#3 SUB2006-00235

WIMBLEDON SUBDIVISION, 2nd UNIT, BLOCK 13, RESUBDIVISION OF LOTS 18, 19 & A PORTION OF LOT 17

WIMBLEDON SUBDIVISION, 2ND UNIT, BLOCK 13, RESUBDIVISION OF LOTS 18, 19, & A PORTION OF LOT 17

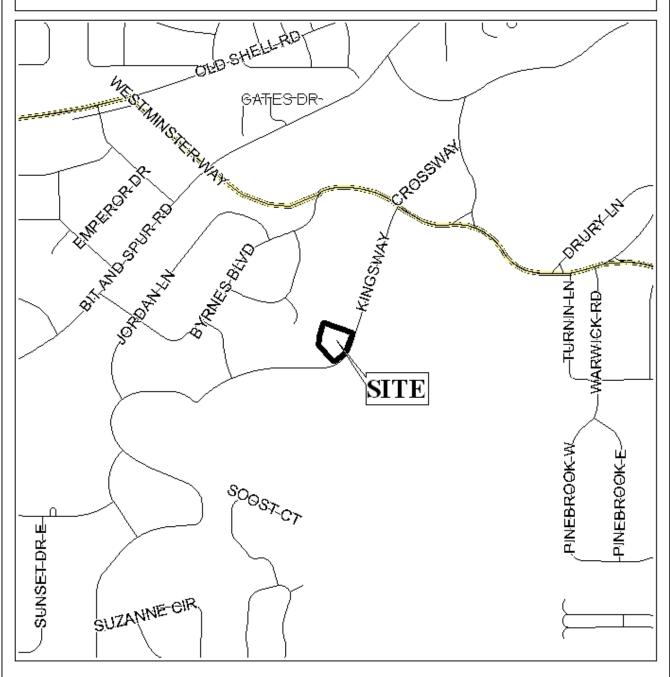
Engineering Comments: It appears a drainage easement is needed. On New Country Club Estates, 8th Unit, a 15' and 10' drainage easement was shown. Show existing pipe and easement on plat.

The purpose of this application is to subdivide two legal lots of record and a portion of a third legal lot of record into two lots. The remaining portion of the third legal lot of record was sold off via metes and bounds legal description in 1992 by the current owner of record, according to the records of the Mobile County Tax Assessor. Therefore, that remainder of the third lot should be included in the subdivision, or the property to which it is intended to be included.

Additionally, attached to the application packet is a 2005 property boundary agreement between the owner of record and the property owner to the Northwest. If this agreement alters the original lot lines, the impacted properties should also be a part of this subdivision application.

Based on the preceding, it is recommended that this application be heldover until the December 7 meeting, with submission of a revised plat and legal description to include the remainder of Lot 17 and illustrating the boundary agreement, along with any required additional fees to Planning by November 15.
